REV. DETAILS DATE
1 SSD DA SUBMISSION 20.06.14
2 SSD VARIATION - FOR REFERENCES REFER JBA S96(1A) 06.05.15
MODIFICATION APPLICATION - TABLE 1: PROPOSED
MODIFICATIONS
3 SSD VARIATION - FOR REFERENCES REFER JBA S96(1A) 10.06.15
MODIFICATION APPLICATION - TABLE 1: PROPOSED
MODIFICATIONS

PROJECT
UNIVERSITY OF NEWCASTLE
New SPACE

DRAWING TITLE
3D VISUALISATION &
MATERIALS BOARD

DRAWING No.
DA-000

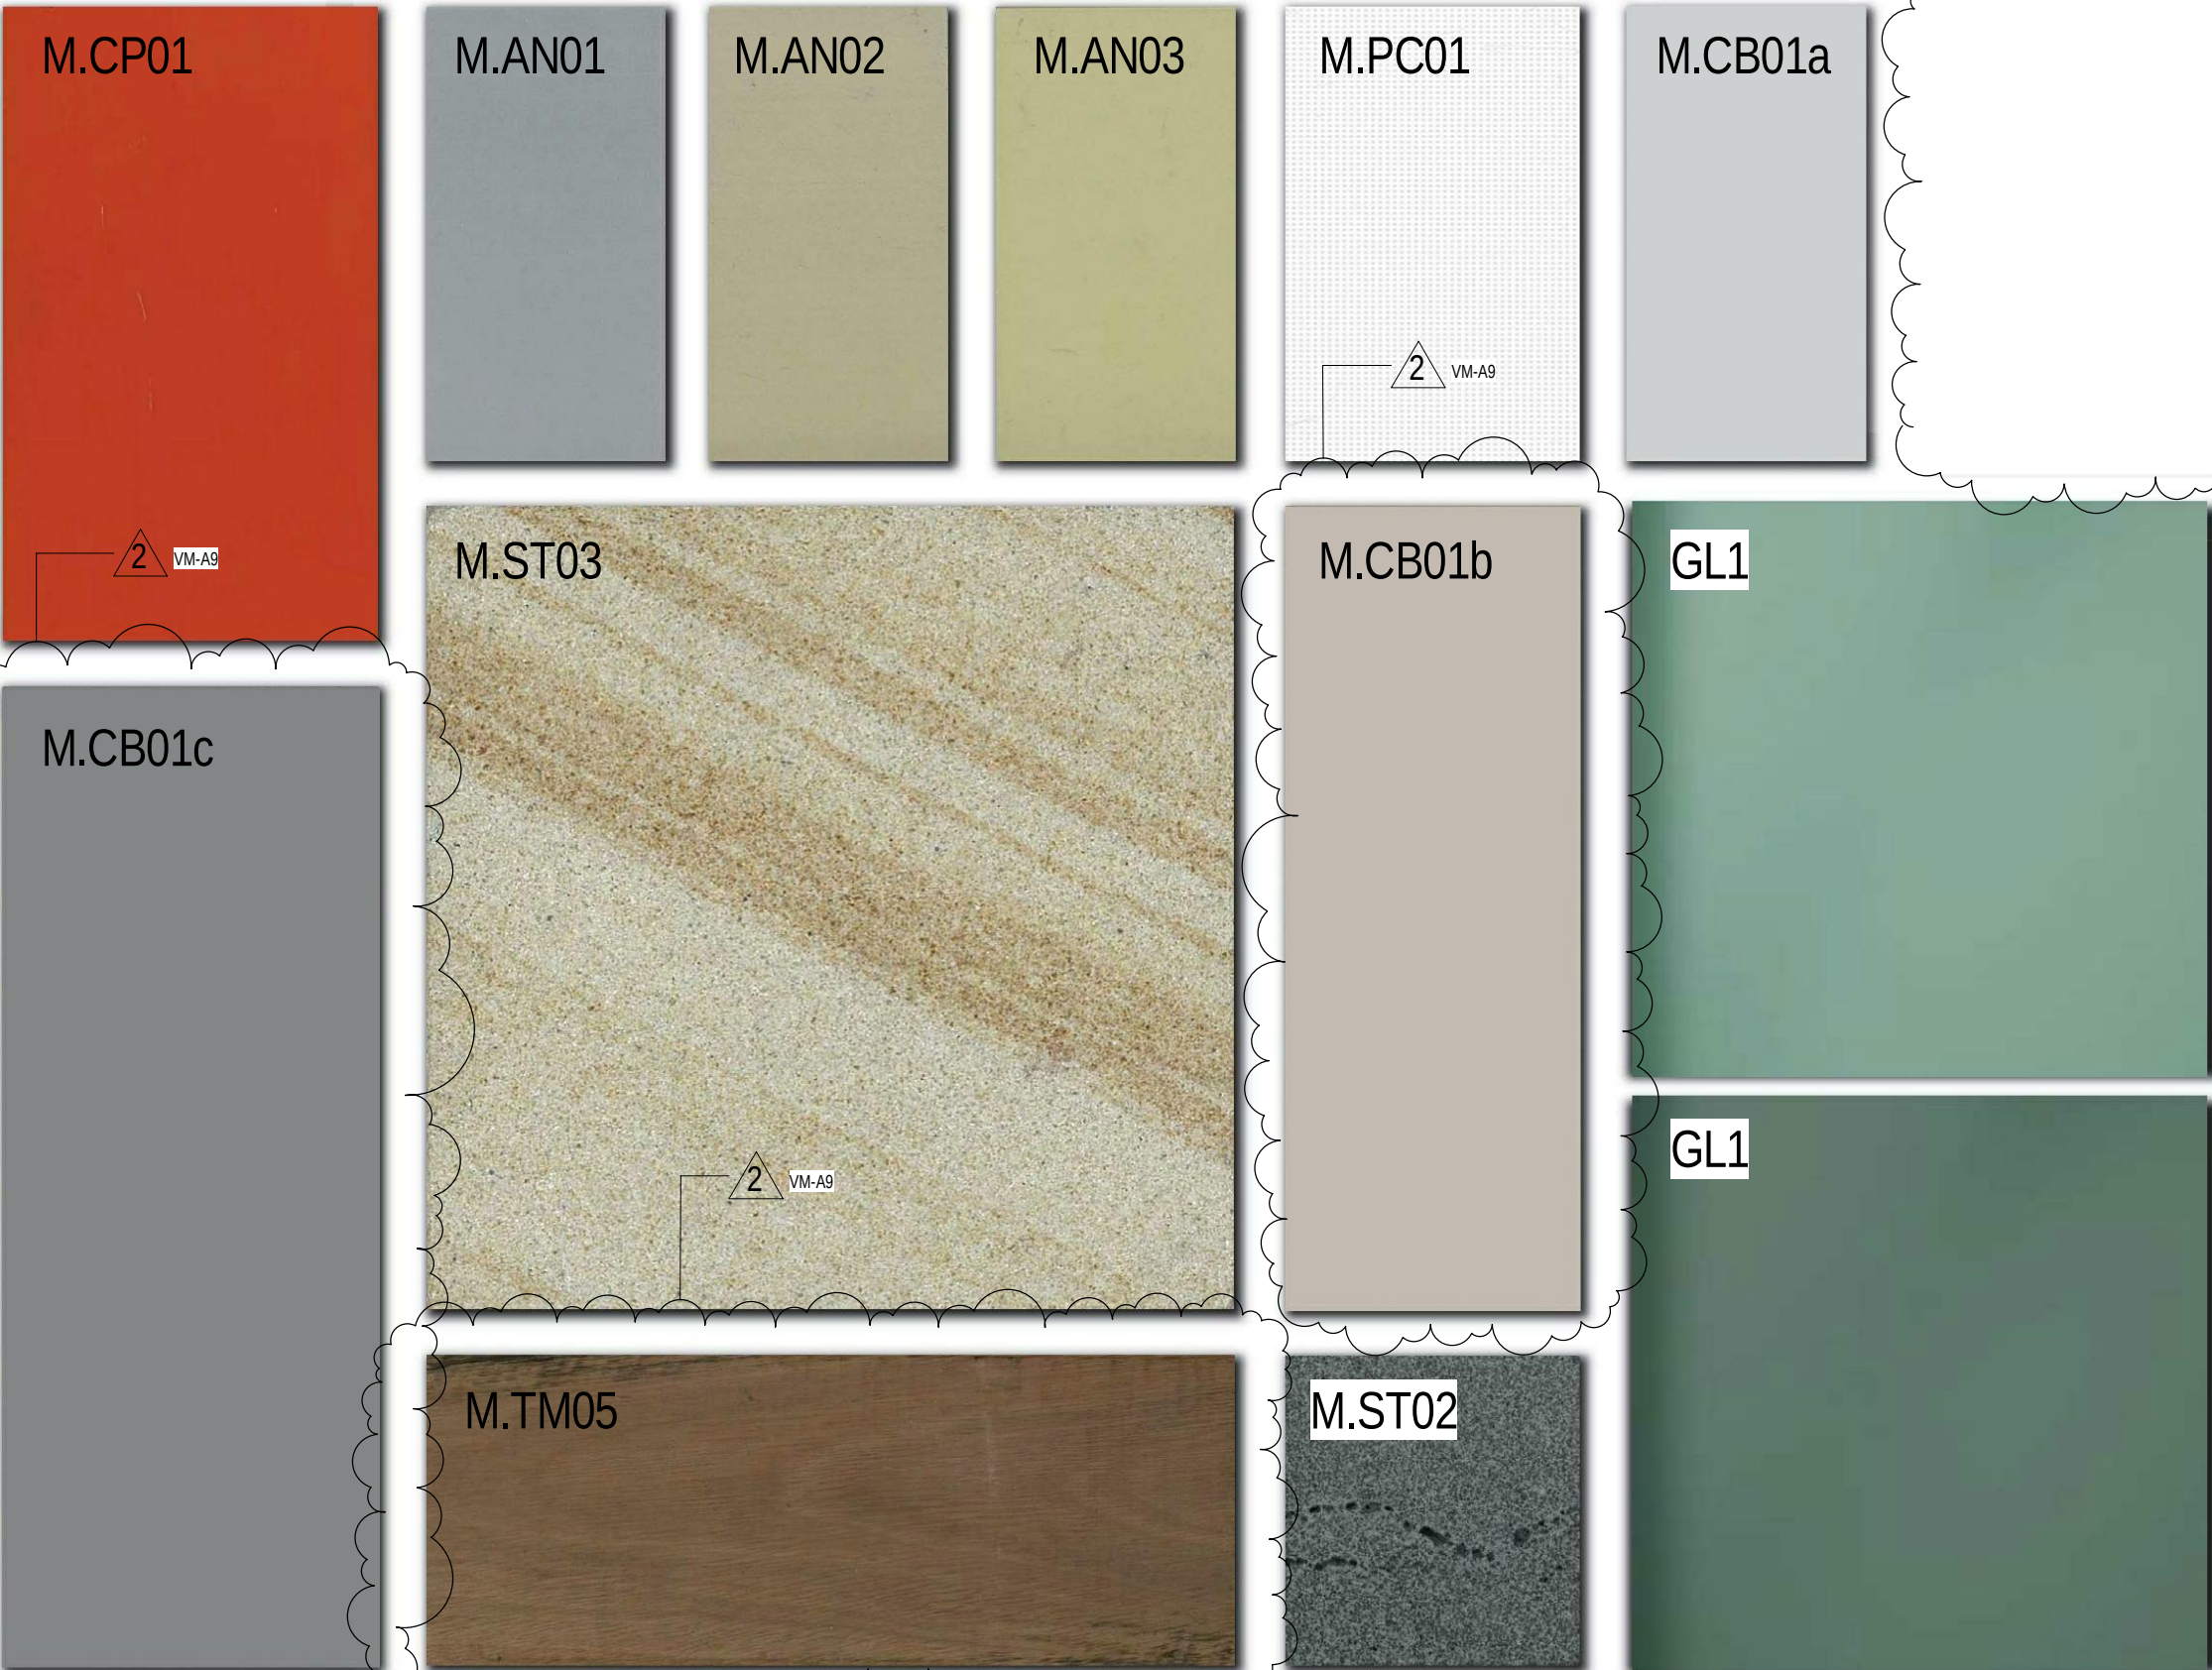
GL-11, M.CB01a, M.CB01c, M.ST01 REVISED

2 VISUALISATIONS REVISED TO REFLECT EXTERNAL FINISHES SCHEDULE
